June 17, 2025

Zoning Board of Appeals Agenda

Re: Application for Area Variance for Off-Street Parking Setback
Proposed Mixed-Use Development
Premises: 45 Beekman Street, High Street, & High Street Beacon, New York
Tax Parcel IDs: (5955-19-706012, 5954-26-689990 & 5954-26-781983)

Image 2. Annotated Excerpt of Enclosed Landscape Plan:

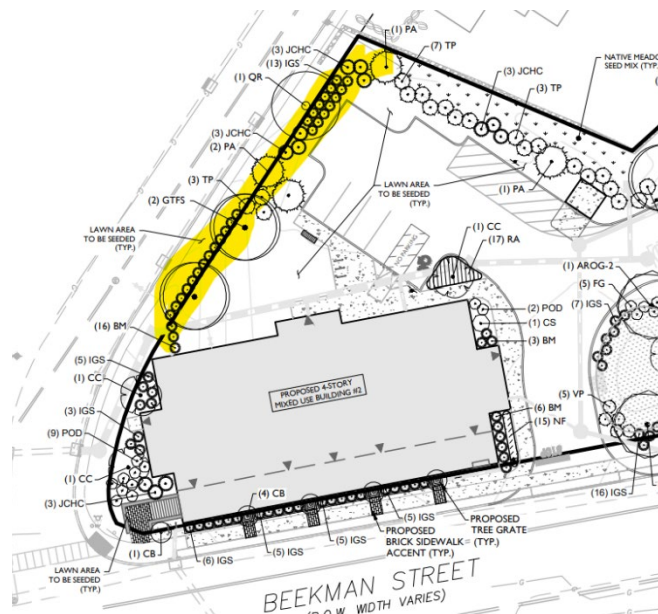
While I imagine that it was not Cuddy + Feders intention, their plan view of the applicant's building and parking lot is a good representation of what the neighborhood on High Street will see. Given the relative heights of the applicant and High Street properties, the screening shown, in my view, is woefully inadequate—as the site will be seen from high above.
